RFT 26-083 Interior Renovations & Air Conditioner Upgrades at Frontenac PS

The following, issued by the Halton District School Board (HDSB) June 18, 2026, shall be incorporated in the specifications and shall form part of the proposal document for the above.

TENDER ADDENDUM NO. 1
2026.06.17

Interior Renovations and Air Conditioner Upgrades at Frontenac Public School
Halton District School Board RFT 26-083
5140 Pinedale Avenue, Burlington, Ontario

ONE(1) HDMI OUTLET,
 ONE(1) VGA OUTLET
 ONE(1) 3.5mm AUDIO PORT
 AND ONE(1) USB OUTLET c/w CABLE
 AND STAINLESS
 STEEL COVER PLATE.

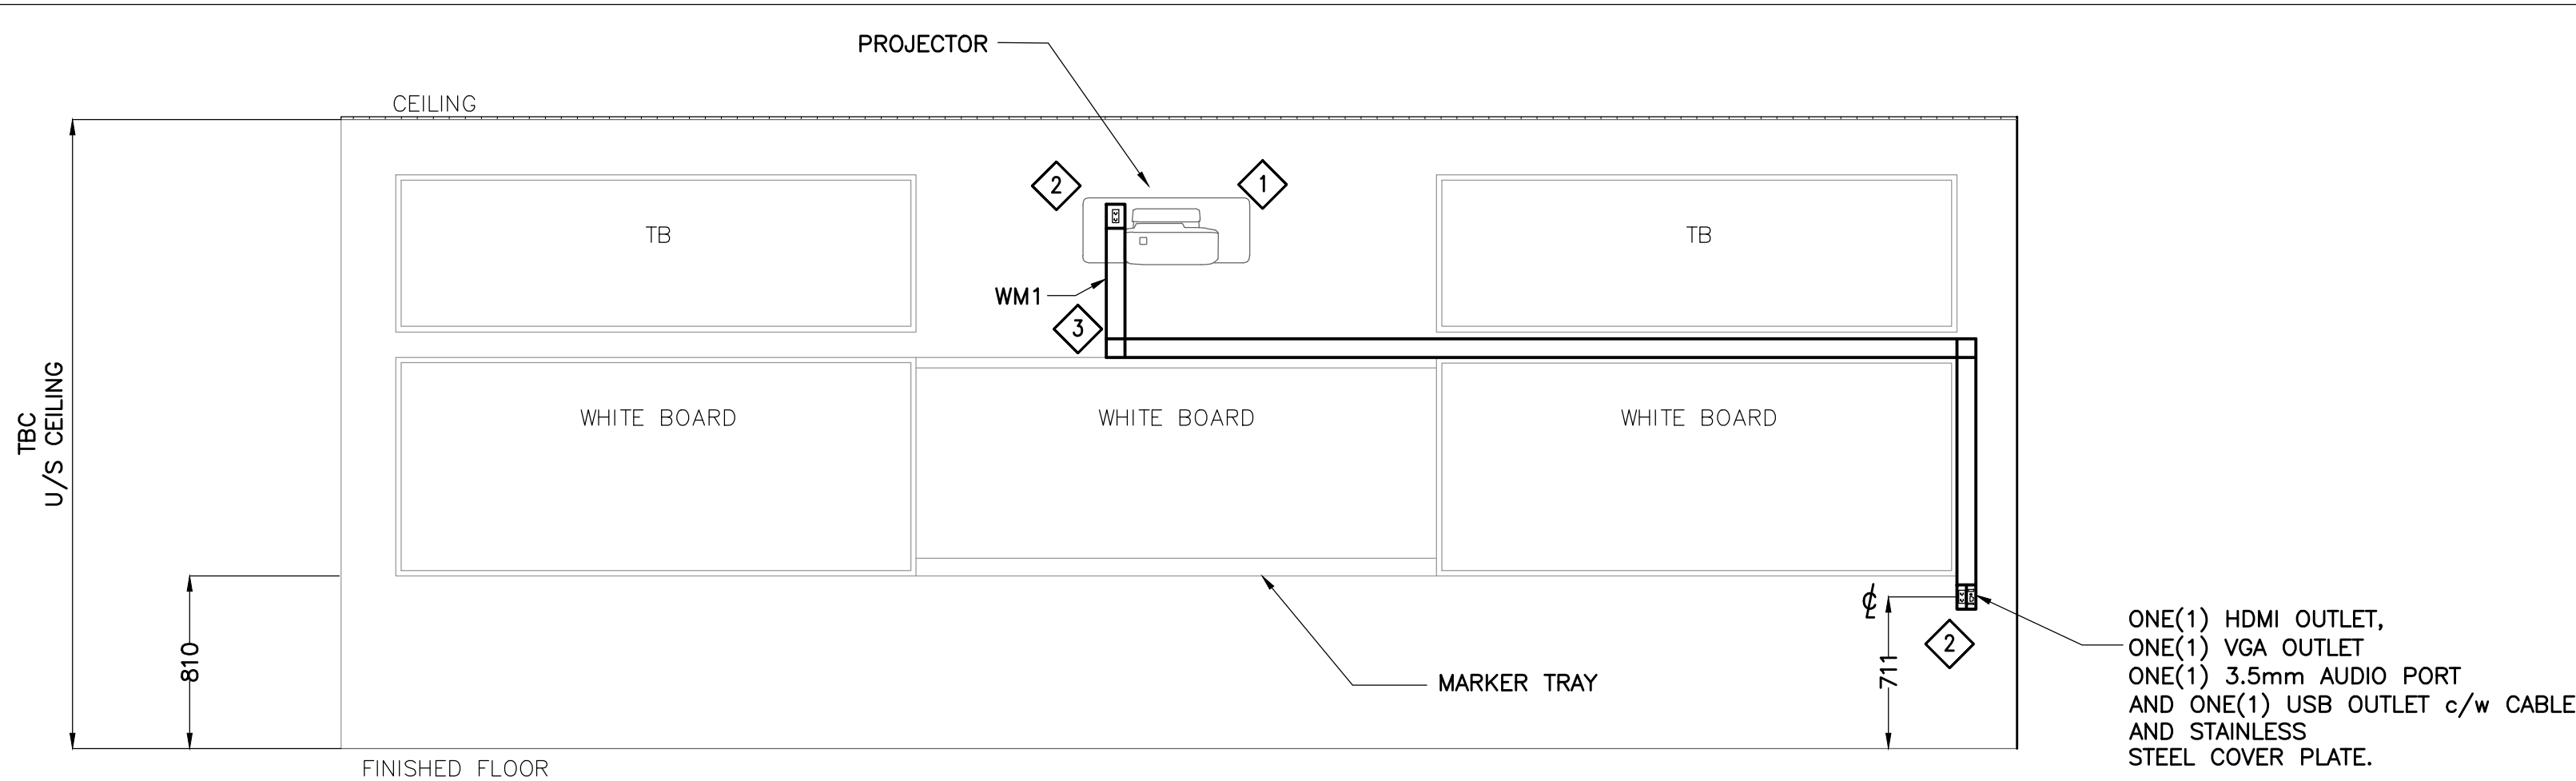
- 1.4 Refer to revised Electrical Drawing E1.5 Rev.A
 - Added new drawing sheet E1.5.

Drawing No.:
E3.1

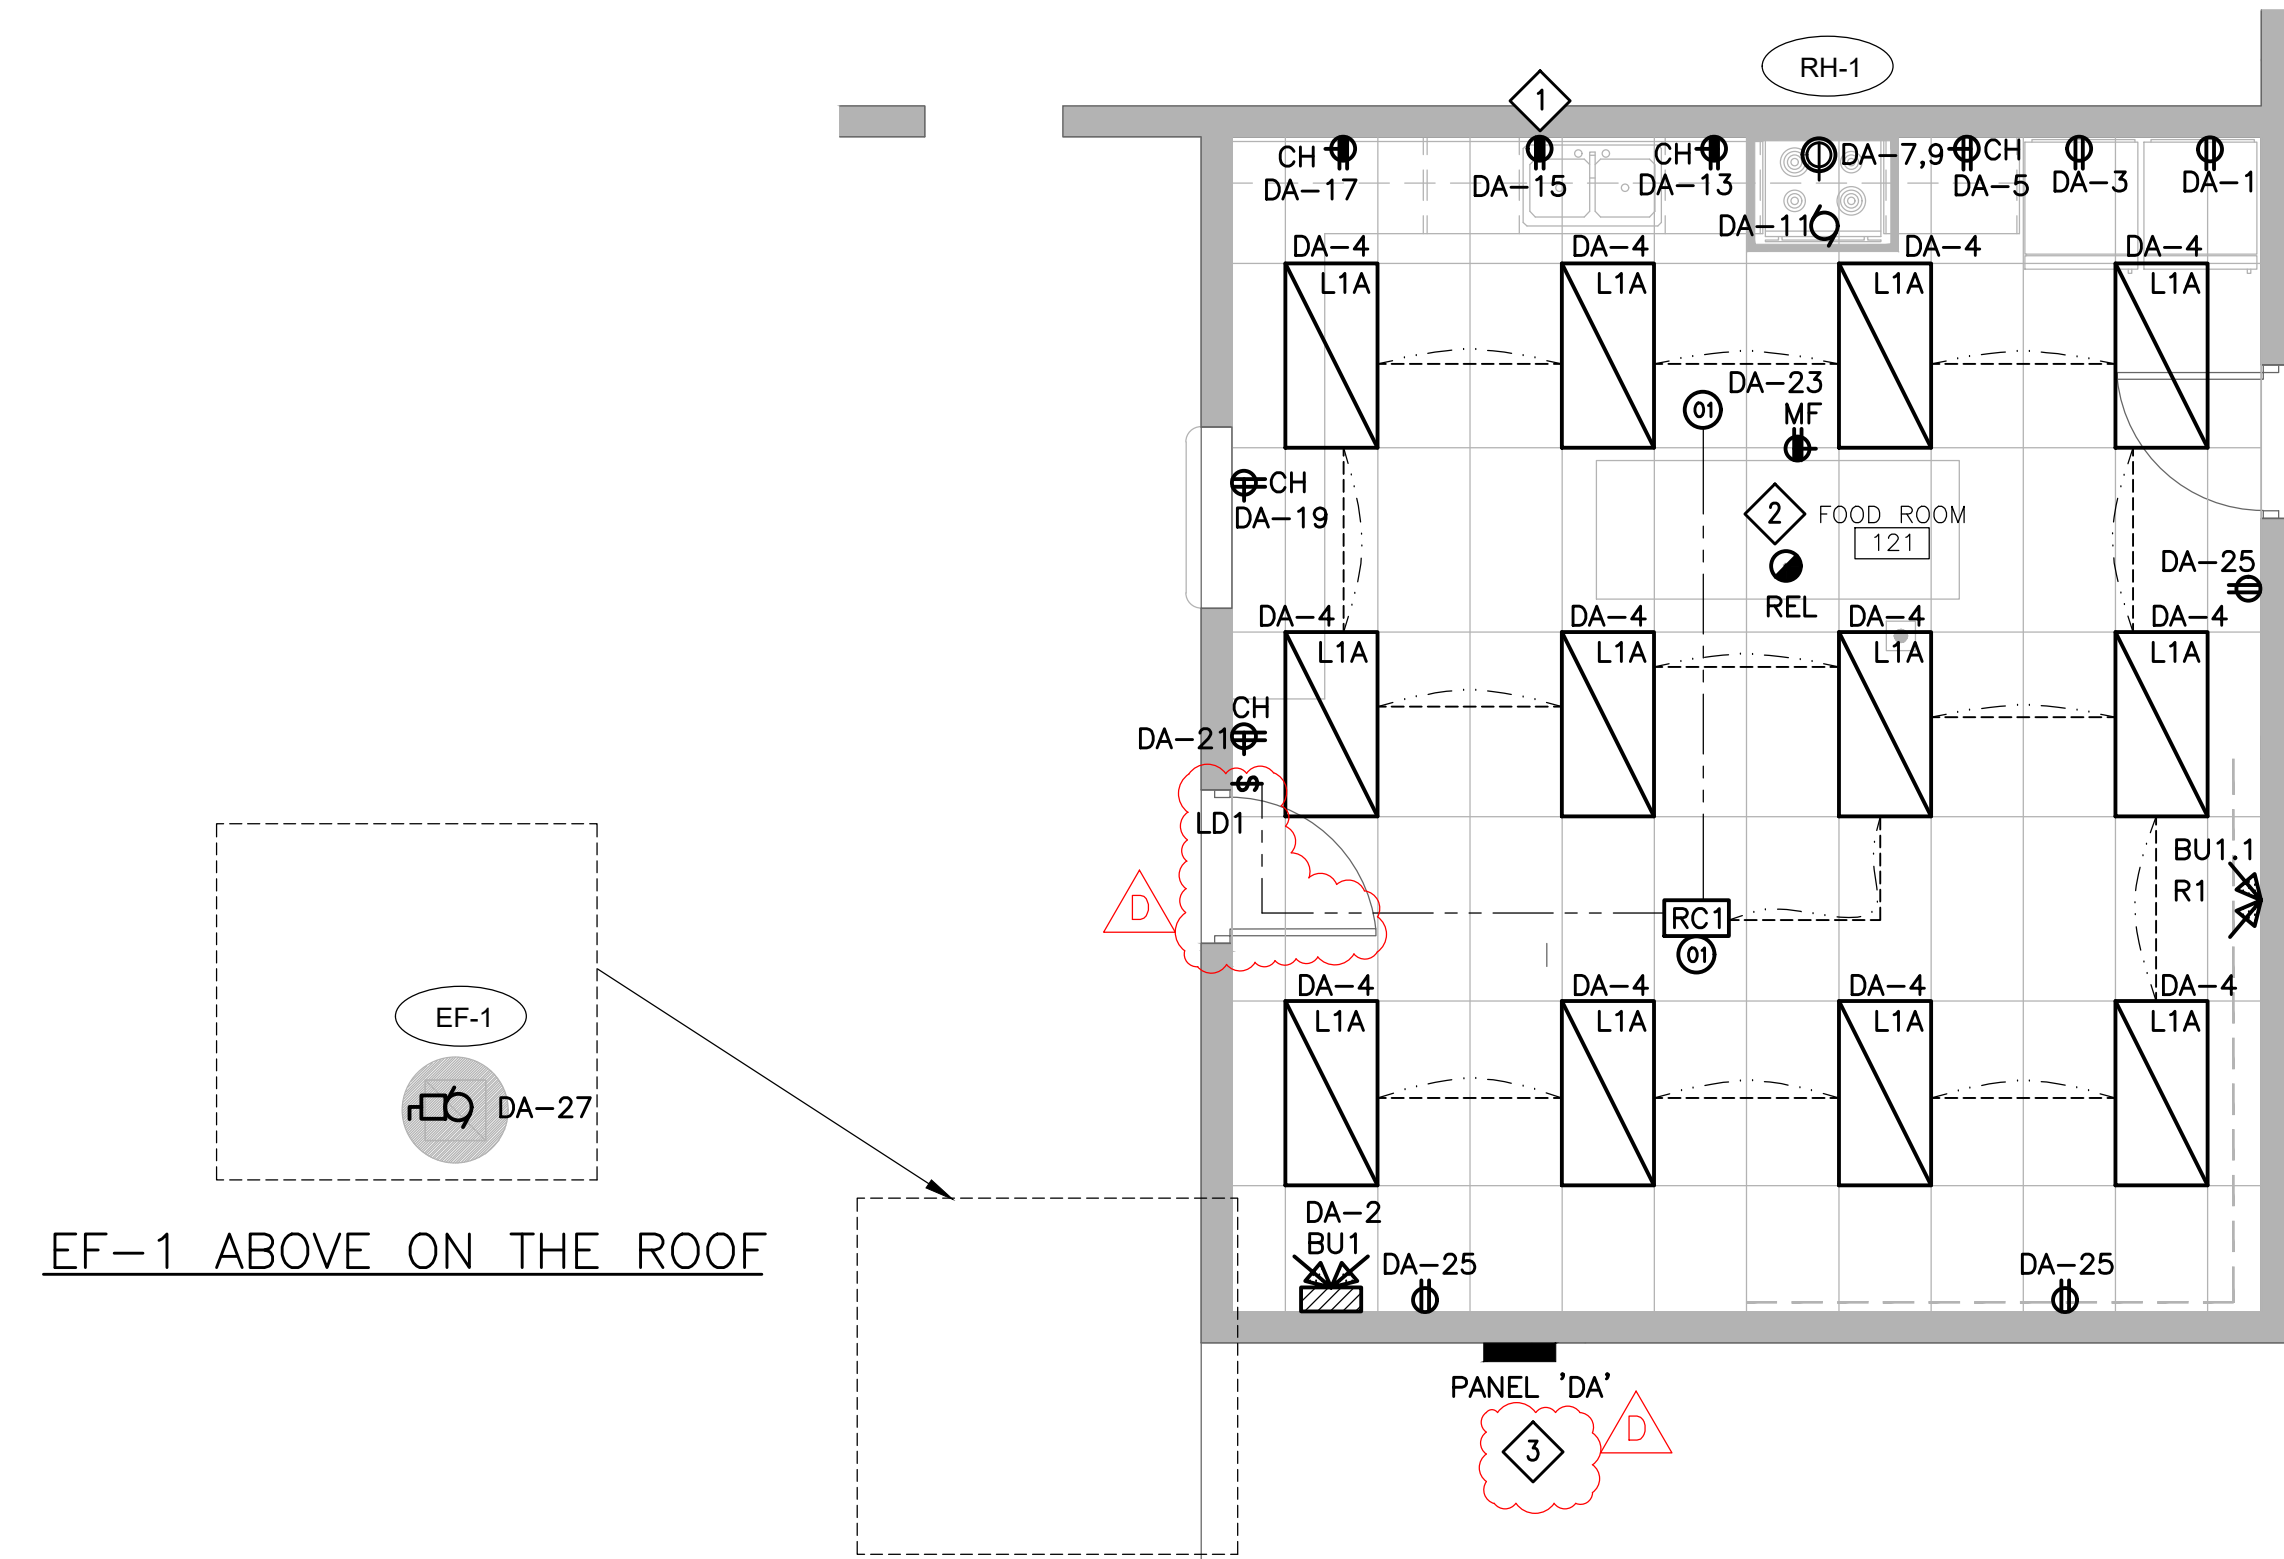
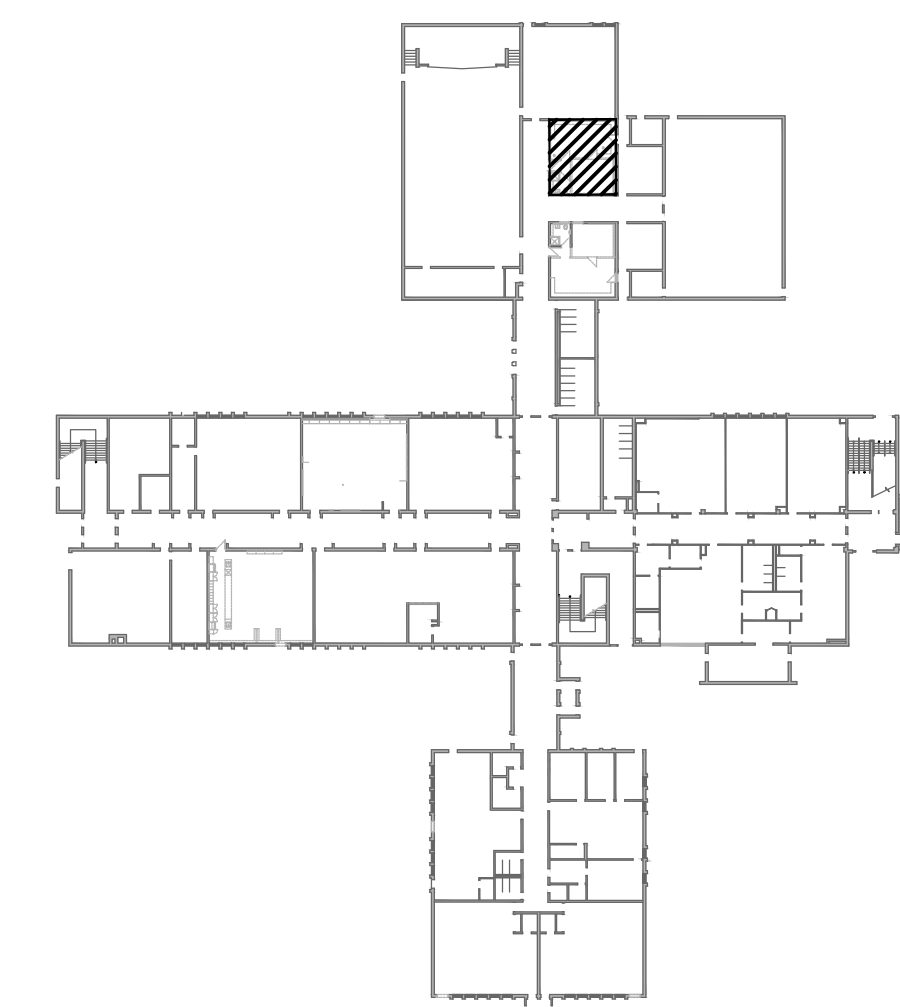
- 1.5 Refer to revised Electrical Drawing 3.1 Rev.D
 - Relocated a light switch.
 - Added drawing keynote 3.

Drawing No.:
E3.2

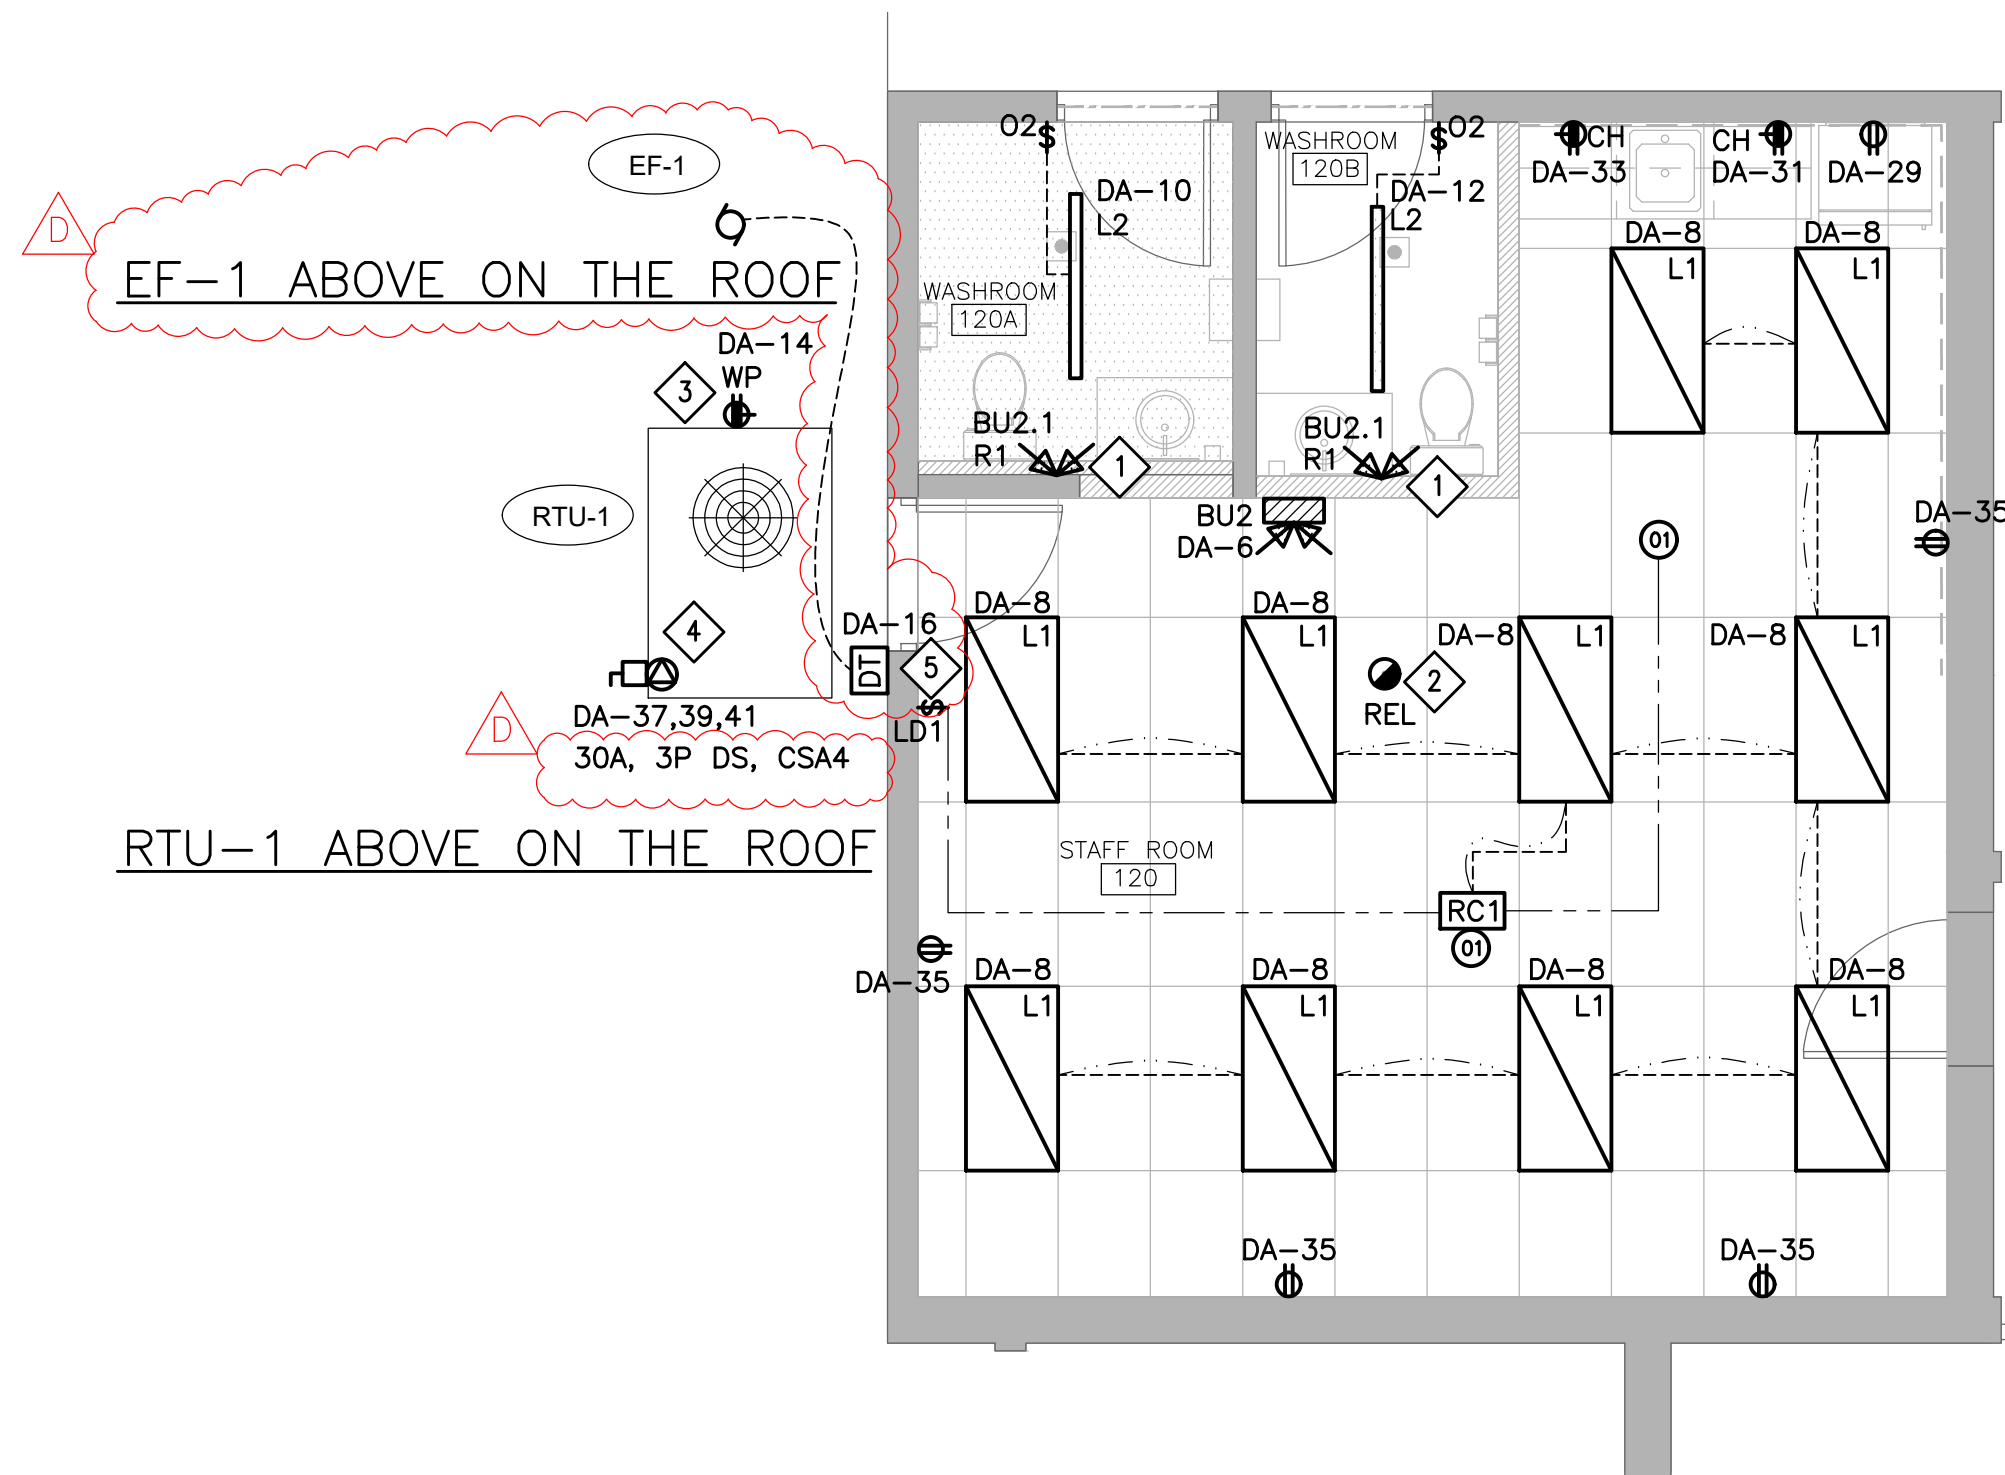
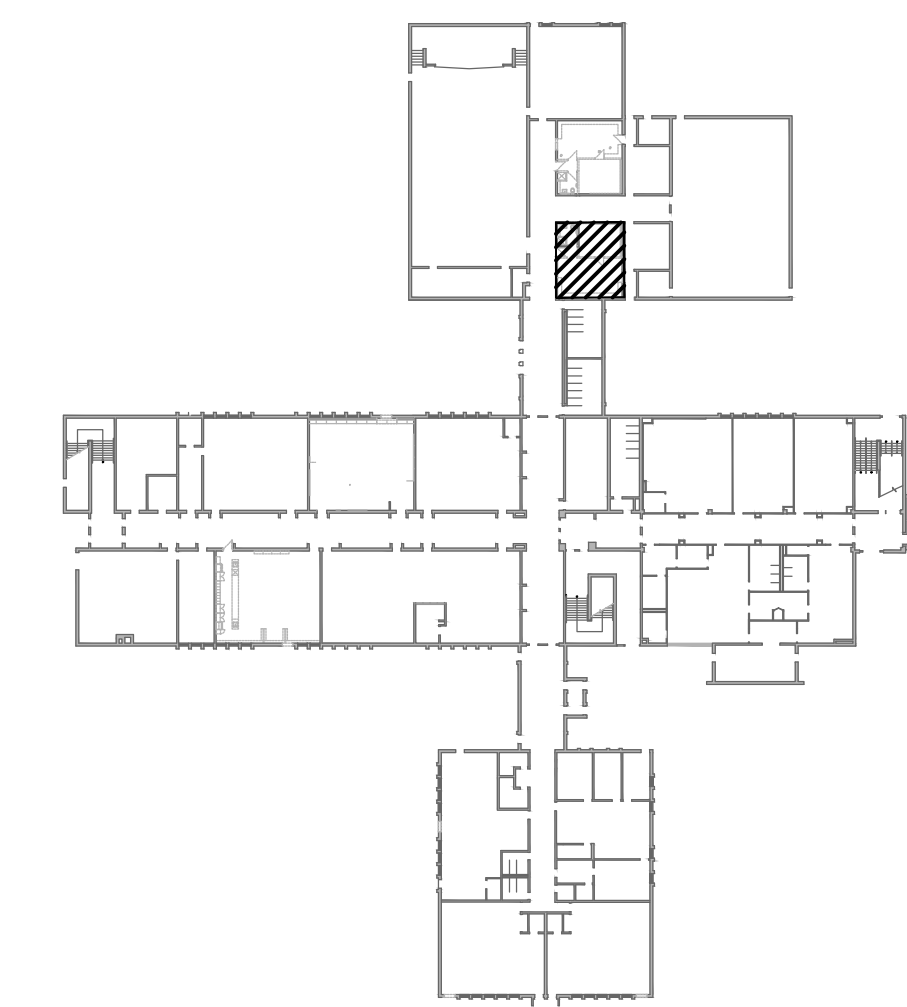
- 1.6 Refer to revised Electrical Drawing 3.2 Rev.D
 - Revised a disconnect switch details.
 - Added exhaust fan 'EF-1' and Digital timer.
 - Added keynote 5.
